# Access Compliance Report

## Public Rights-of-Way

### (Pedestrian Signals)

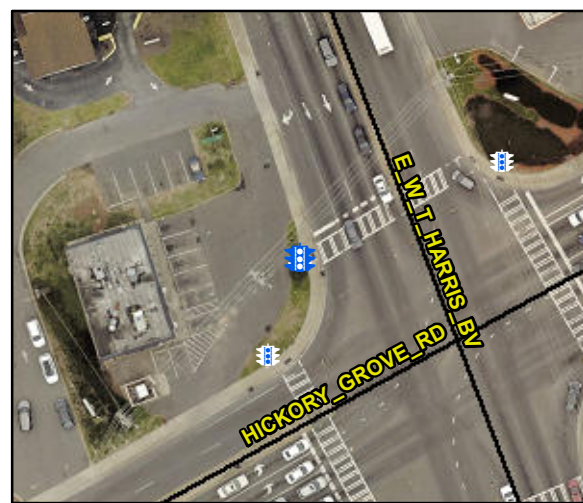
Intersection ID: N/A	Main Street:	Cross Street: N/A	Location: N/A
ADA ID: F95065CEB6C8	Signal Type: One Push Button-Non APS	Overall Compliance: No	Severity Score: BTN 1: N/A BTN 2: N/A No BTN: N/A
Codes/Mitigation Info/Possible Solution		Field Measurements/Component Compliance

Surveyor Notes: TEXT HT 7/16

PROW/ADA: R410.6, TMUTCD 4e.08, R404.2, R404.3, R404.7.3

Possible Solutions: Replace Signal Push Button With APS Button on New Post. Remove & Replace Sign.
